MEMORANDUM

From:	Tina Cuss Ecology Officer		
Service	WBC Ecology	App No:	242936
Address:	Land At Rear Of, 6 Johnson Drive, Finchampstead, Wokingham, RG40 3NW.		
Proposal:	Application for submission of details to comply with the following conditions of planning consent 223592 dated 09/06/2022. Condition 5 relates to a Construction Environmental Management Plan (CEMP), 8 to biodiversity mitigation and enhancements, 9 to a Landscape and Ecology Management Plan (LEMP) and 13 to drainage details.		
Type of Development:			
Site Visit Made:	No

Examples of activities requiring a licence near a badger sett.

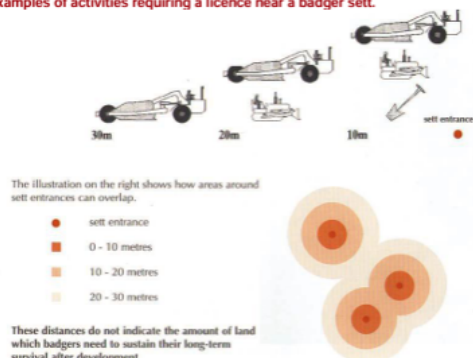
I disagree that the detail of the Badgers Toolbox Talk proposed is appropriate for development site. I don't support the proposal that tree protection fencing is raised 200m off the ground to allow badgers unrestricted access throughout the construction site once grassland and potential foraging has been cleared. This is inconsistent with the proposal for erection of reptile fencing which would either obstruct or be damaged by badgers accessing the construction site. I don't agree that avoiding creation of large stockpiles of earth would avoid impact and mitigation for loss of foraging, as the CEMP doesn't include proposals to retain or dismantle existing spoil heaps or consider soil stripping, storage and importation likely to be necessary/proposed. I request that pre-commencement checks and site-specific species mitigation is proposed in the amended CEMP.
